**Evaluation of Environmental Shadow Flicker
Analysis for “Dutch Hill Wind Power Project”**

R.H. Bolton
January 30, 2007
Rev. 1b

UPC Wind's has proposed two wind farms for Cohocton, the Cohocton Wind Power Project is first, the Dutch Hill Wind Power Project is the second. A DEIS for the Dutch Hill Wind Power Project has been submitted that includes a shadow flicker impact study (Ref. 1)

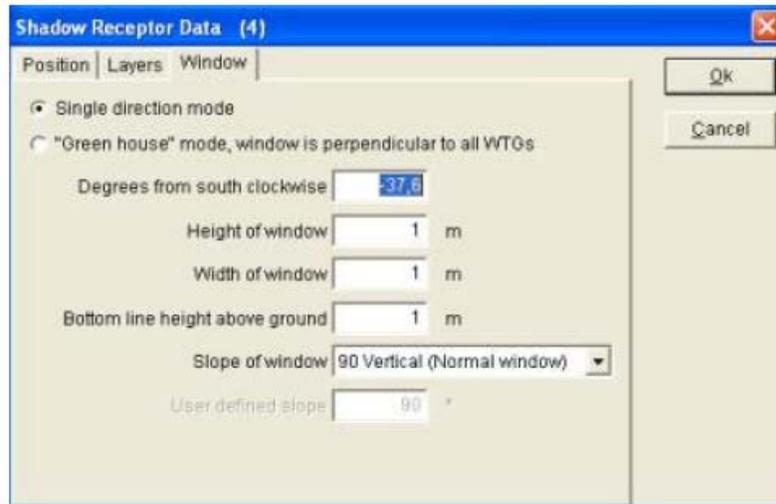
This modeling approach is not at all a “near worst case” analysis and is indeed a minimal case analysis because it only assumes shadow flicker is a nuisance if it occurs on a home

window. Then only a minimal 1 m² (about 3'x3') window at each receptor is selected, ignoring shadow effects on the residence as a whole or property.

Fig. 1: Iso-Shadow Plot Segment

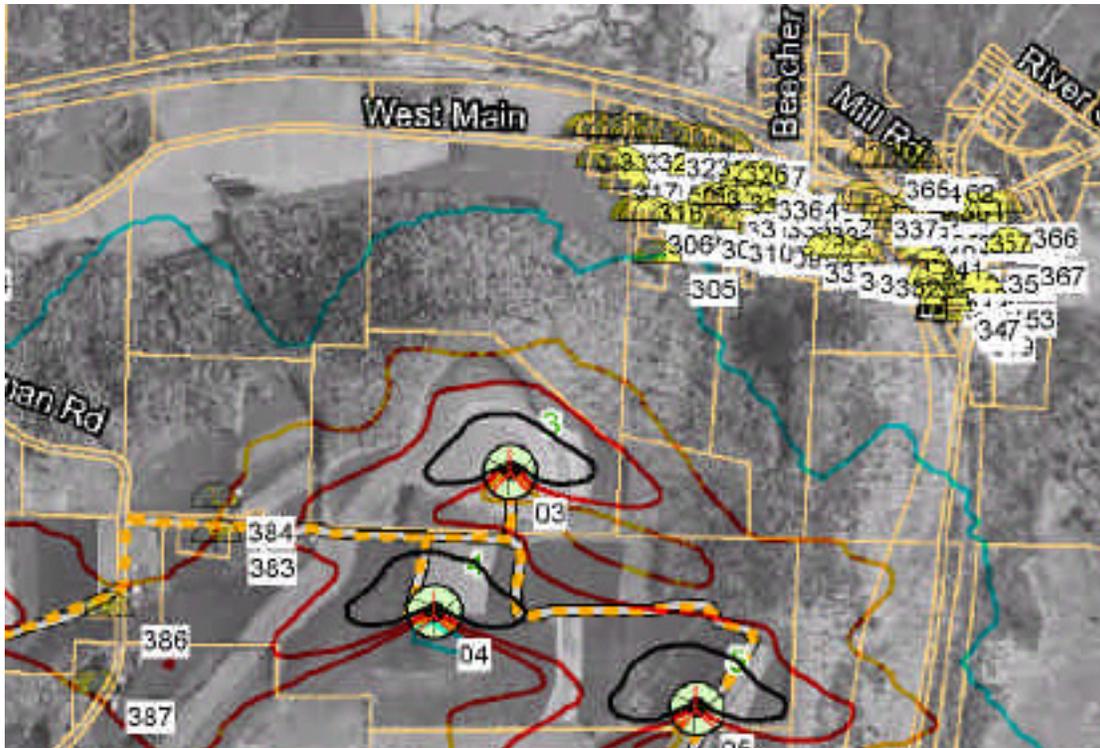
A much better picture of the shadowing extent is given by an iso-line plot of shadows which WEI has WindPro output for various sections of the project. An

example for Atlanta and Dutch Hill is shown below in Fig. 1. The quality of the plot in the WindPro output is rather poor so a decisive reading is difficult. Turbine #3 on Dutch Hill is shown to be about ½ mile from downtown Atlanta and according to the WindPro plot no shadowing will occur there. As will be discussed below in Section 4.3 however a simple benchmark computation for a ridgeline turbine shows that shadows can easily extend 2 to 4 miles. And for Atlanta the effects will last about an hour every morning. The entire hamlet of Atlanta it will likely be significantly impacted by turbine #3, #4 and #5 shadow flicker.

Fig. 2: Observer Close to Blades

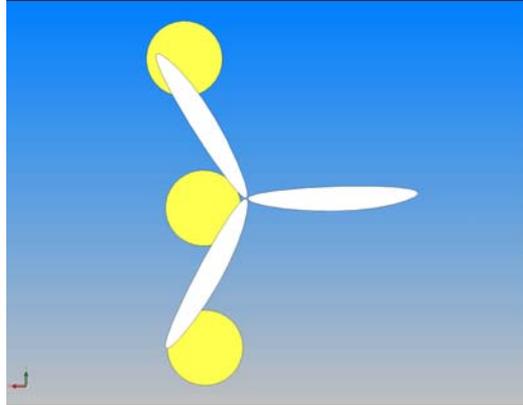
WEI does not indicate its familiarity with WindPro software nor any benchmark field tests it's ever performed to authenticate or bracket its predictions. We are therefore to believe that the software is written correctly, tested for accuracy by the authors and that WEI has setup and operated WindPro correctly. Any seasoned engineer quickly learns that modeling software must be very carefully used and verified to engender confidence and error sensitivity. At a minimum some crude benchmark calculations have to made by conventional means, which will now be done. To calculate blade flicker the propagation distances can easily be checked. The sun is a very distant object and always has nearly the same angular subtense of about 11 mrad (milliradians) to an observer. When looking through turbine blades toward the sun, the size of the visual impact depends on distance between the observer and the turbine. Thus if the observer is very close to the turbine blades the blades will be large in comparison with the sun, as illustrated in Fig. 2 below. As the observer-to-blade distance increases the proportion of the blades covering the sun decreases as shown in Fig.3.

Fig. 3: Observer More Distant from Blades

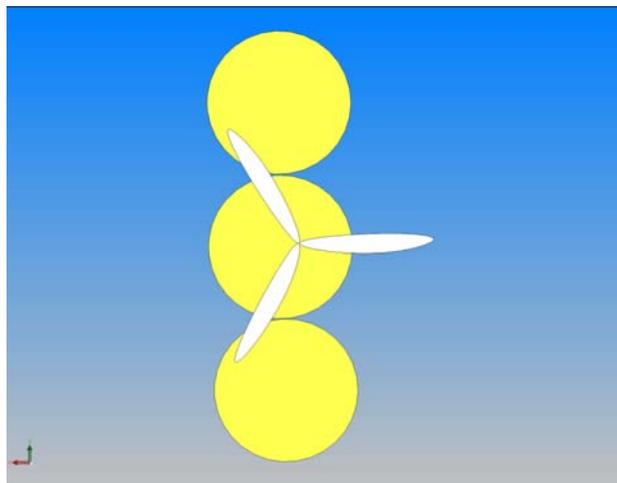
Using this information some simple distance calculations can be done. For example when the blades just cover the sun they will occupy an angle of 11 mrad. The 3-blade diameter for the 2.5 MW Liberty Clipper turbines is about 300 ft. Using simple geometry the distance the observer would be for the sun to just cover 300 ft. is $300' / 11 \text{ mrad} = 27,000 \text{ ft.}$, or 5 miles. This very long distance can only occur when the sun is at a low angle over the horizon.

Fig. 4: Shadow Geometry

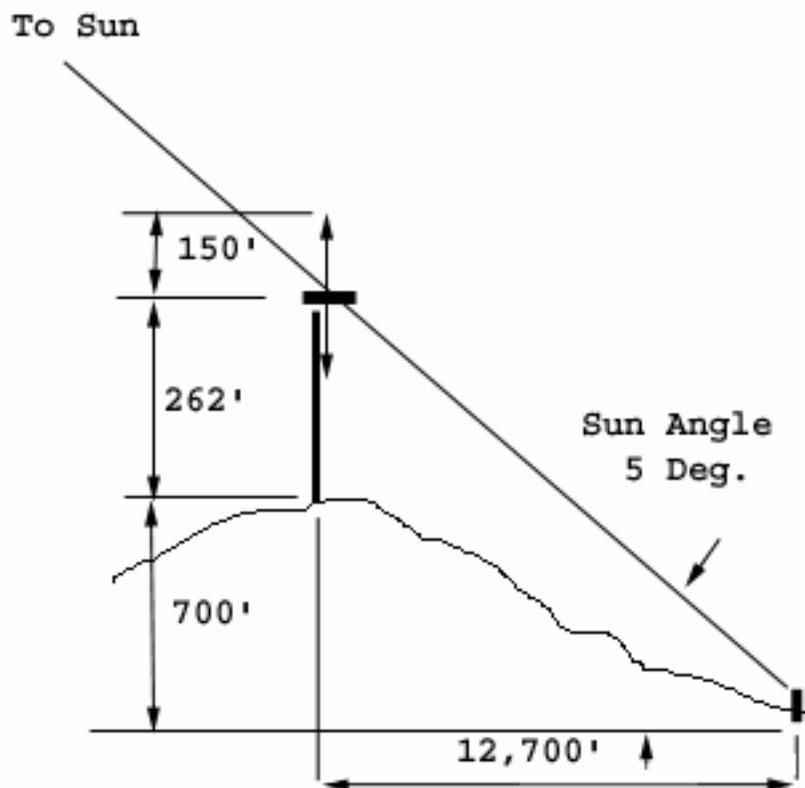
As WindPro states, it calculates a 4.8 km (15,600') observation distance for a 45 m (150') diameter disk, ½ the size of the much larger Liberty units. Contrary to WindPro's flat-terrain assumptions, turbines on elevated ridgelines will cast very long shadows into the adjacent valleys because the sun will rise much higher in the sky. For a 700' high north-south ridgeline (eg Dutch Hill towering over Atlanta) and a 262' high nacelle the 300' diameter rotors will cast over a 2 mile shadow when the sun is at 5 degrees. This calculation is illustrated in Fig. 4 below.

The flickering turbine shadow will be seen in the valley below the ridgeline shadow. Ridgeline shadows easily cast very long shadows as is well known to anyone living in a situation like this. For example the author frequently experiences the well defined ridgeline shadow of Bare Hill cast on opposing Johnson Hill across Canandaigua Lake, over a mile distant.
